Our Ref: ARO0188

Response to Information Request Reconfiguring a Lot (One lot into nine lots and road) at 368-380 Port Douglas Road, Port Douglas (RP Lot 3RP729037) (ROL 2022_4962/1)

The following information is provided in response to Council's Information Request dated 27 October 2022.

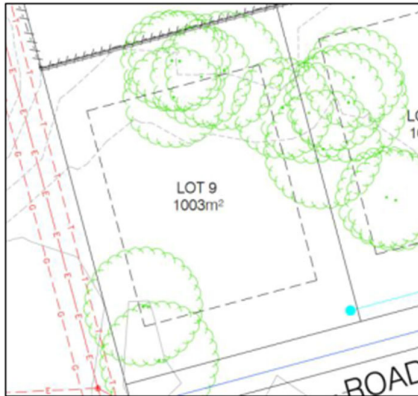
- 4. The proposed layout does not provide the minimum verge width on the eastern end of the tee head. Please provide a design that includes the minimum verge width, or justification for why any relaxation should be considered. The current 1-1.5m verge is not acceptable.

Response: The layout plan has been amended to provide the full verge width.

Attachment 1 - Amended Layout Plan ARO0188-SK05(1)

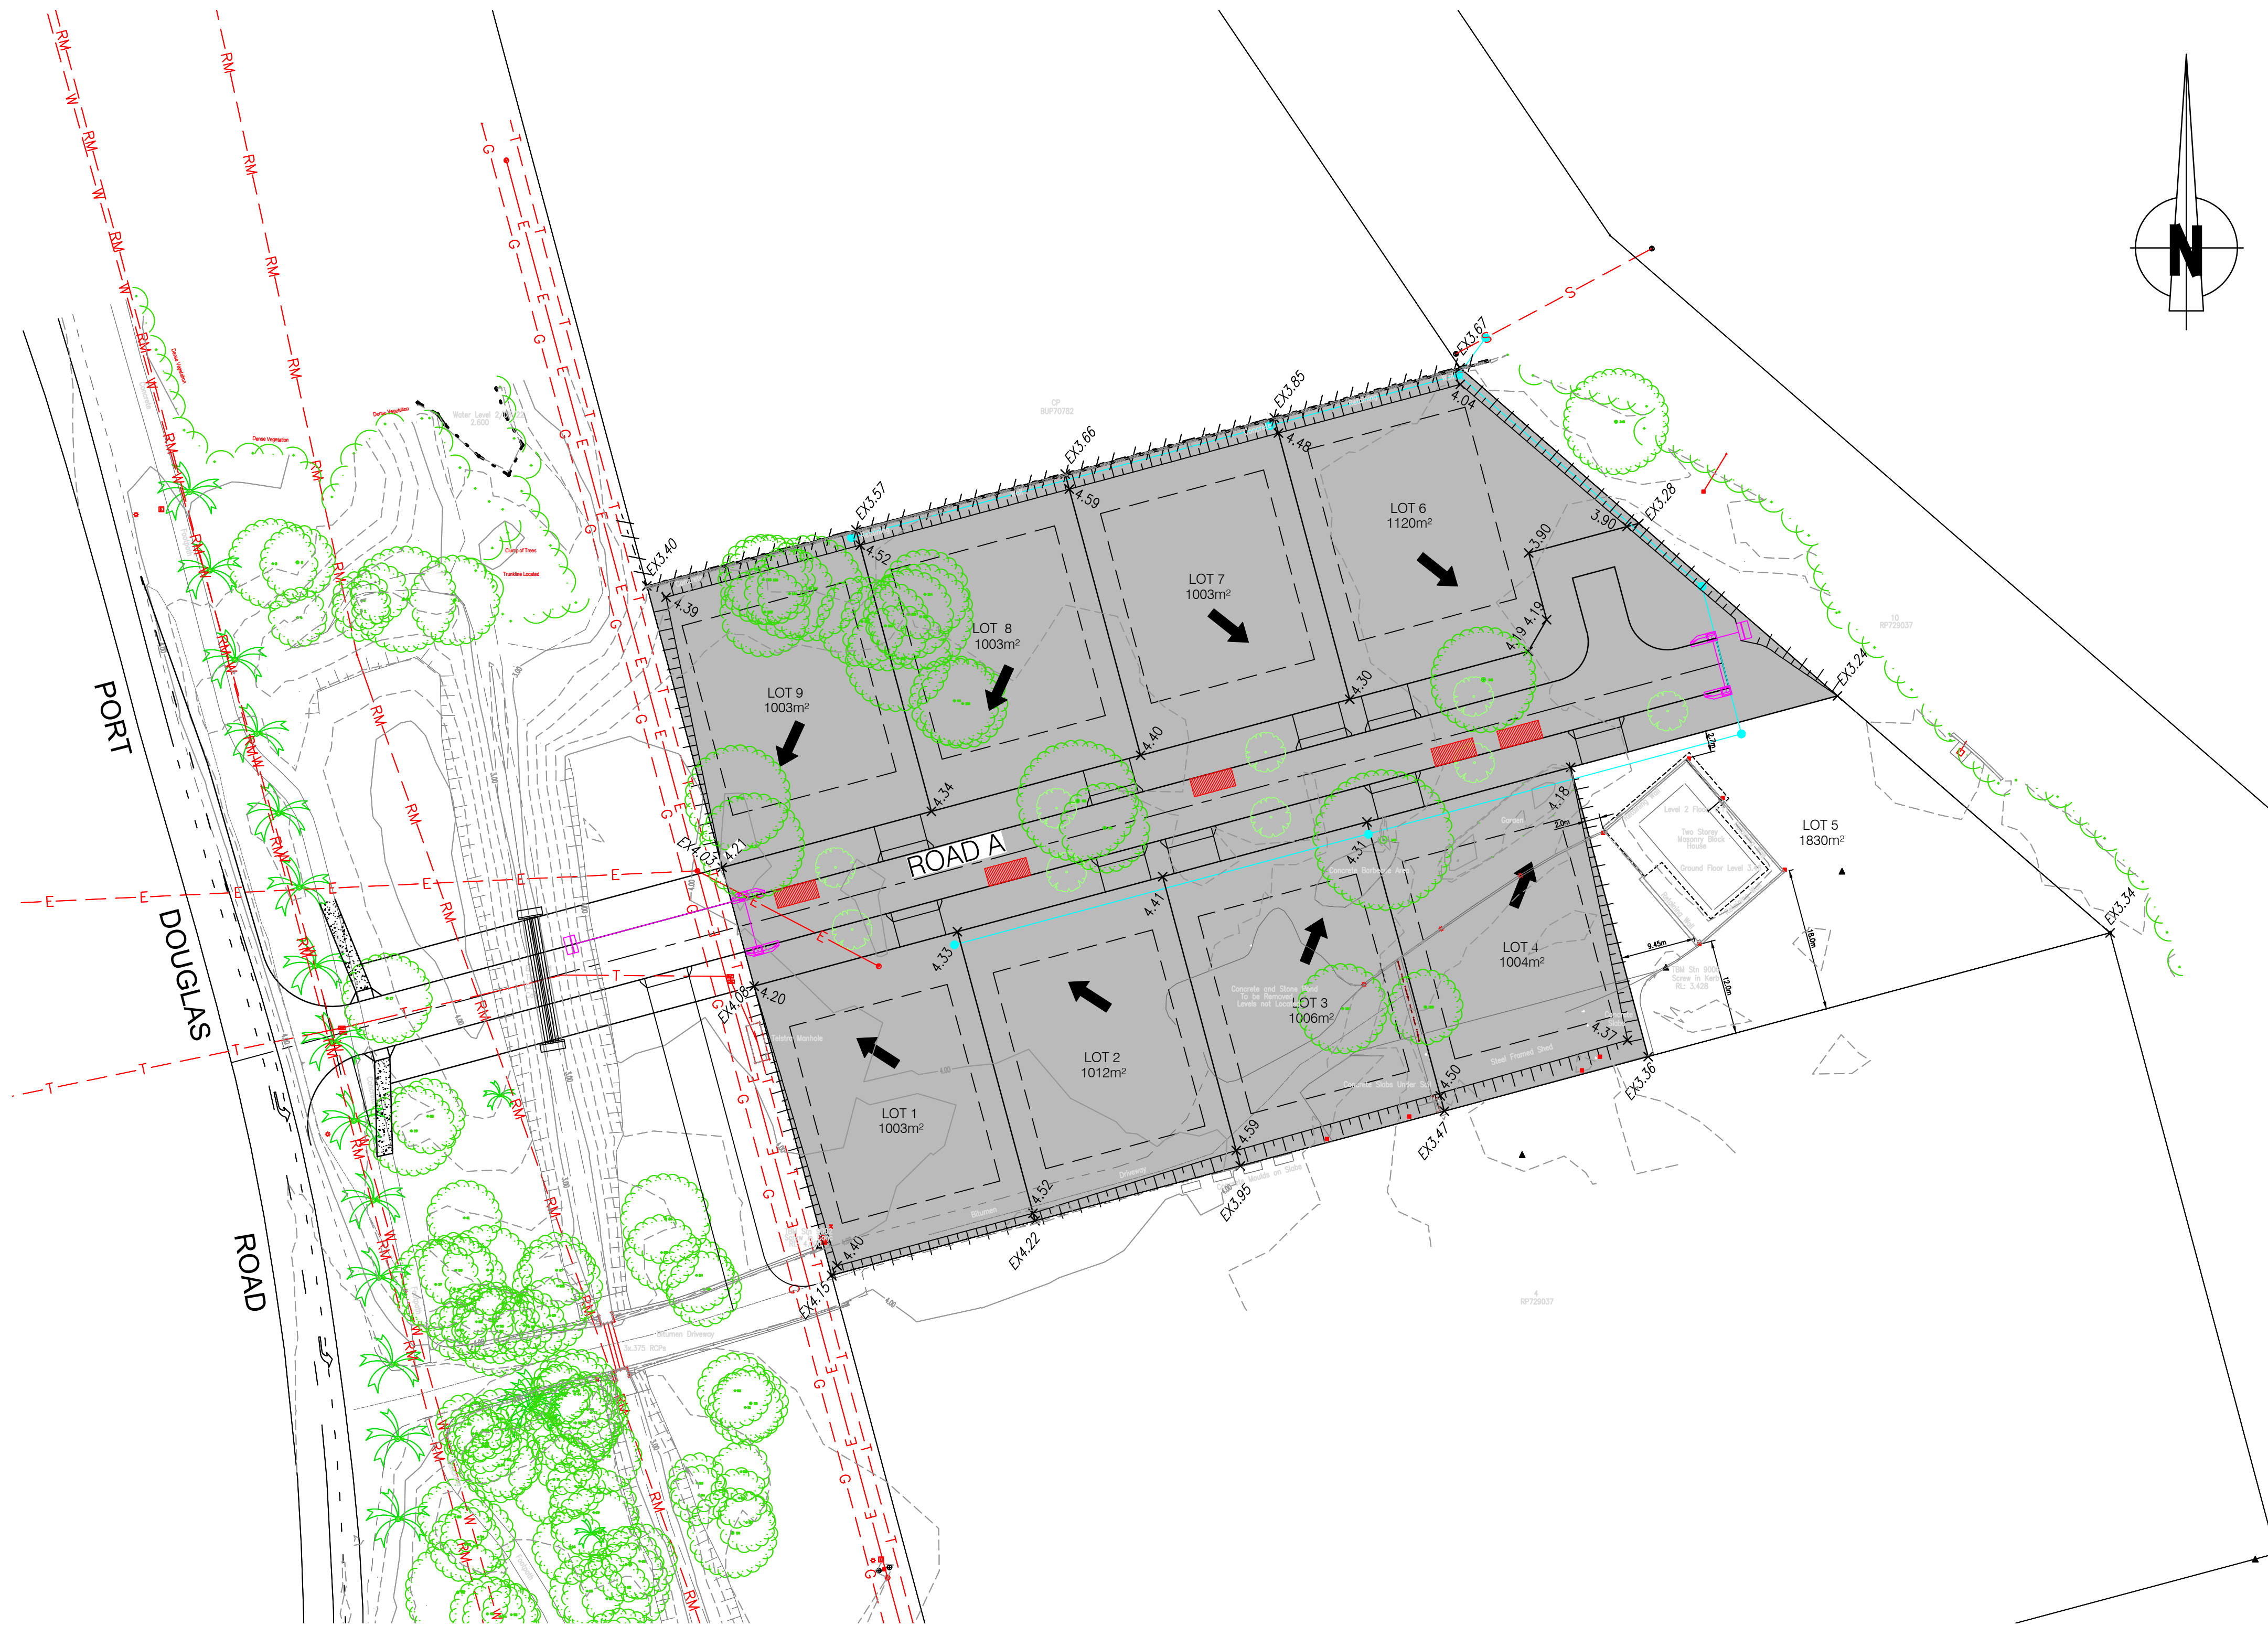
- b. The existing access also provides for the neighbouring land to the south. Please provide written advice from the neighbouring landowner that there is agreement that the existing access will be closed and what is the intended alternative access for this neighbouring lot.

- 3. Proposed Lot 5 fronts the turning head and has no opportunity for on-street parking. Please provide advice and plans demonstrating where on-street parking can be accommodated within the road reserve.

- 6. Please clarify the purpose of the rectangles drawn within each new lot.

7. The plans detail the existing ponds on the land that appear to remain on Lots 3 and 4 in the design plans. The planning report accompanying the application states on page 8, "The site will be designed and profiled to drain to the lawful point of discharge." Please provide a lot layout plan, that is dimensioned and to scale that details the intended finished contours for the new lots. The plan of the development is to include the intended connection to Council's water infrastructure and the extent of the plans should include the whole width of the adjacent Port Douglas Road.

10. Concern is held with the intention to construct sewer infrastructure on the adjoining freehold land. Please provide advice as to the ability to ensure the sewerage reticulation infrastructure is contained within the subject site, other than a simple connection, and not rely on the adjoining lot.

16. Please provide a plan showing all the street trees and vegetation, from the centre line of the road pavement to the property boundary. Please note, Council does not support the removal of the oil palm. Relocation of the palm is not recommended due to its size there is a high risk of trauma/ loss of the palm.

*Response: It is noted that the address for the neighbouring property (4RP729037) is 2-14 Old Port Road, Port Douglas and a lawful point of access is from this local road. Notwithstanding, a new sealed access will be provided from the new road to the neighbouring lot. Refer to amended Layout Plan ARO0188-SK05(1) provided as **Attachment 1**.*

Response: The amended Layout Plan shows the on-street parking. It is noted that the available on-street parking spaces are within 25m of the property frontages.

Response: The rectangles show the minimum lot dimension as specified in the Douglas Shire Planning Scheme.

Response: The existing ponds will be removed and the lots will be graded to direct stormwater to the internal access street. The layout plan has been amended to show the indicative stormwater infrastructure and overall drainage regime.

Response: The Layout Plan has been amended to contain the sewer within lot 6 with a short section of sewer line within lot 10 for the connection to the existing line.

Response: Refer amended layout plan. The proposed intersection will not result in the removal of any oil palms.

Attachment 3 - Alternative Intersection Location ARO0188-SK06(1)

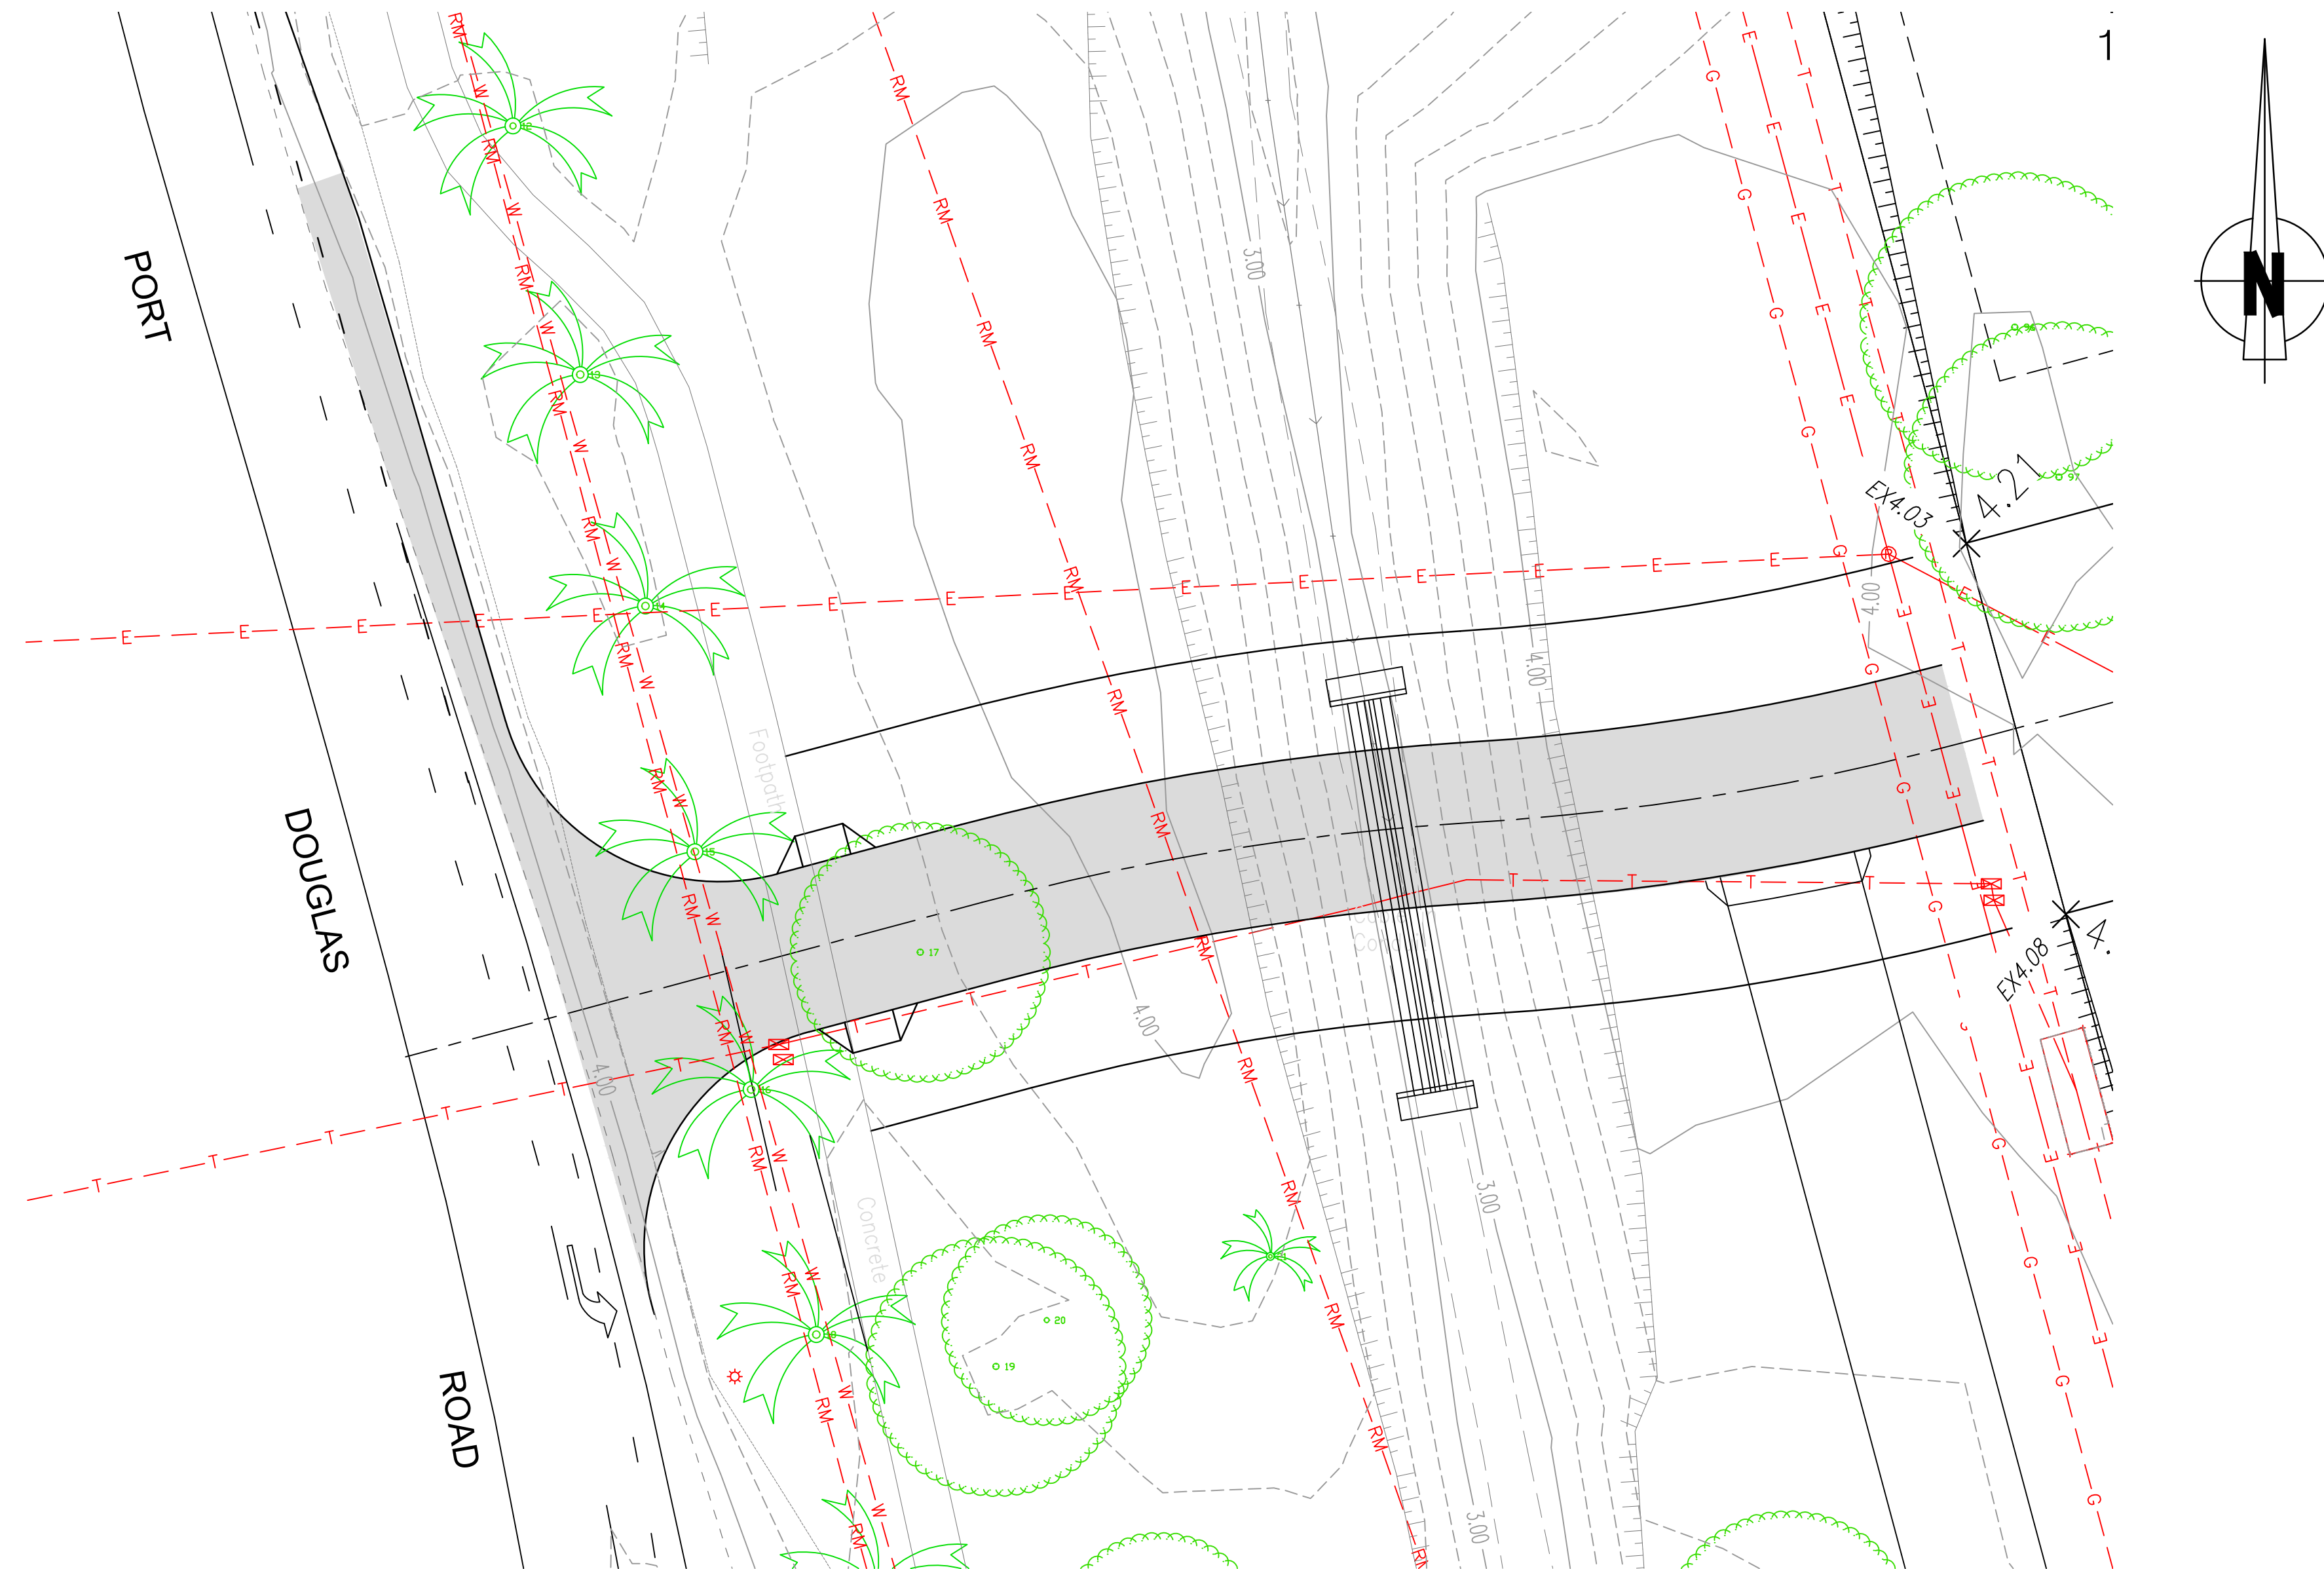
- 5. Concepts for Road A should be further developed and the full footprint of works through to Port Douglas Road shown to demonstrate that drainage, pedestrian connectivity and the streetscape generally are not adversely impacted by the proposed works. Please provide the existing services and street furniture detail on the sketches including the streetlight that appears to be located within the intersection footprint. Noting the level differences between Port Douglas Road and the site, additional information on likely road grading and levels is required. The interface to the existing pathway should be shown for assessment.

*Response: The amended intersection layout is provided on drawing ARO0188-SK06(1) provided as **Attachment 3**. The proposed alignment will not require the removal of the Oil Palms along Port Douglas Road.*
